TECHNICAL BULLETIN

MODEL/DERIVATIVE:
Freelander

Bulletin N°: 0026
CDS. ref: L8665bu
Issue: 1
Date: 22.08.01

COOLANT LEAKAGE - CYLINDER HEAD GASKET FAILURE

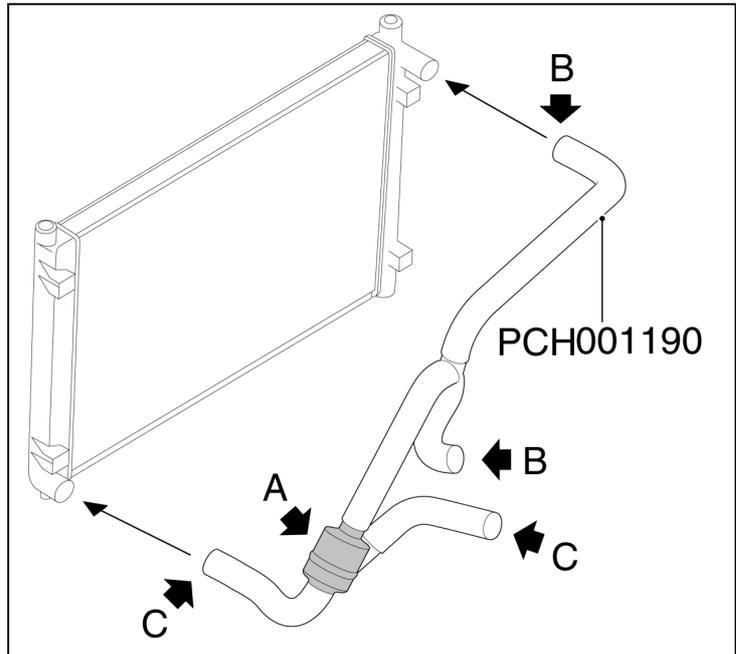
Failure of the cylinder head gasket, due to insufficient coolant flow during engine warm up.

NOTE: A new design of cylinder head gasket and remotely mounted thermostat has been introduced into production at VIN 1A 324162.

3. Replace thermostat with thermostat blanking plate PEL000040 and reassemble using new rubber seal PEF10010.

5. Replace hoses with new hose assembly PCH001190 which incorporates the new thermostat, 'A' in illustration.

Hose connections 'B' in illustration go to the original top hose connection points.

Hose connections 'C' in illustration go to the original bottom hose connection points.
